January 16, 2020

To Laurie Moyer, City of San Marcos Director of Engineering + Capital Improvements:

Figure 1: Map demonstrating the severity of the crash history at Sessom Drive. With continued community growth, the rate and severity of traffic collisions should be expected to worsen.

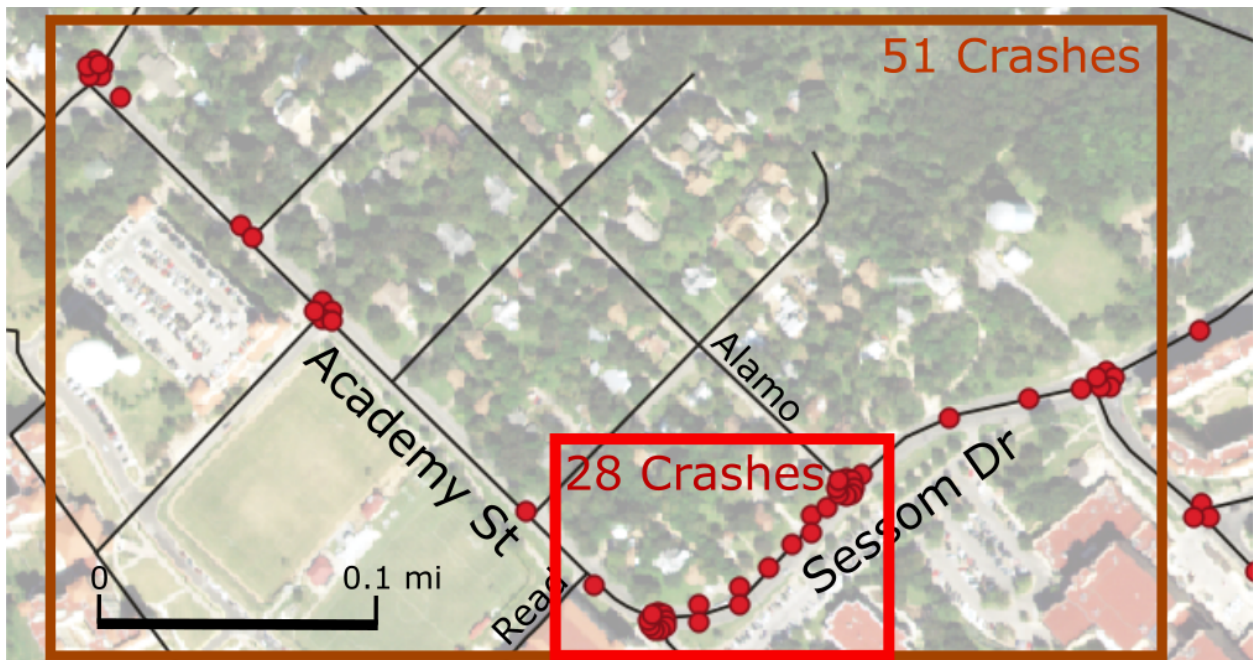
For context, Sessom Drive between Comanche and Holland suffered from over 50 reported collisions between 2014 and 2018, 28 of which occurred between Alamo and Read Street alone<sup>1</sup> (Fig. 1). The current roadway reconstruction project does include added sidewalks in this area and an added traffic control signal, both of which we support. These additions, however, will not reduce traffic conflicts created at several other turning points along Sessom Drive if the planned traffic flow pattern remain the same as existing conditions.

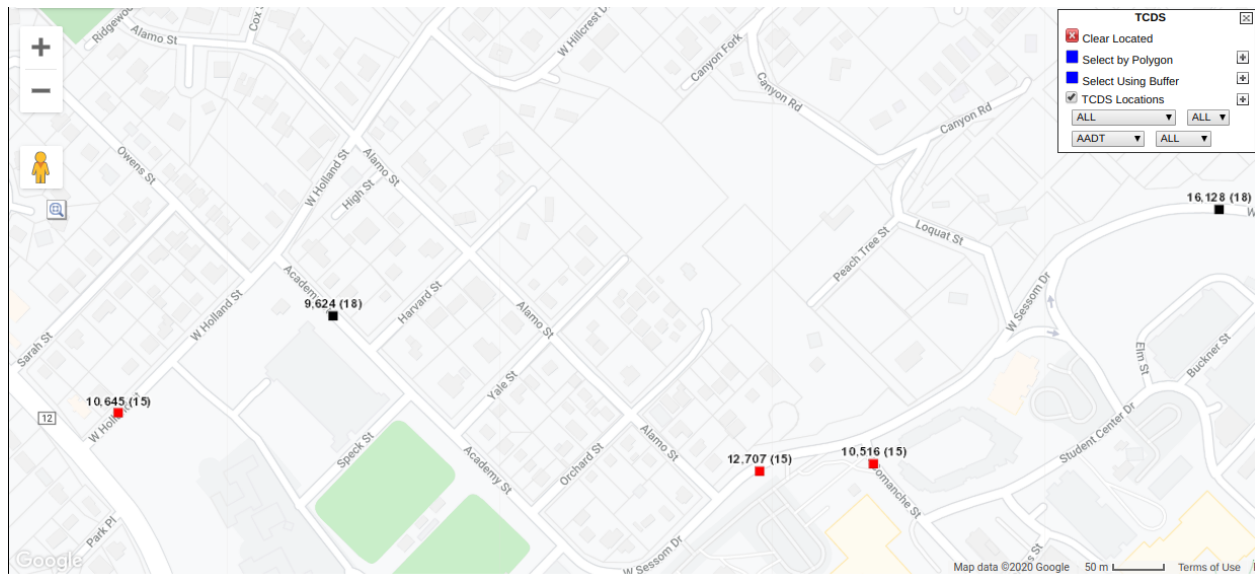
With these safety issues in mind, MoveSM first shared our concerns and suggestions with the City on December 20, 2019. Though we appreciated a thorough response from Mr. Rohit Vij, City Transportation Engineer, on January 8, 2020, we must formally disagree with many of the statements therein. In the response y, the City states that, “[t]raffic along Sessom Drive dictates 2 travel lanes in each direction.” Traffic along Sessom Drive is currently estimated at 12,707 vehicles per day according to the Texas Department of Transportation’s (TxDOT) Traffic Count Database System<sup>2</sup>. Research suggests that four-to-three lane conversions have been successful on roadways with traffic counts as high as 20,000 vehicles per day (in several states, and various sized communities) and that such conversions have not reduced vehicular throughput (and in some cases, vehicular throughput was increased)<sup>3</sup>. Ranch Road 12 is currently only a two-lane design, and furthermore, by local example, TxDOT completed a four-to-three lane conversion on Highway 80, west of Martindale in 2016 (Fig. 2).
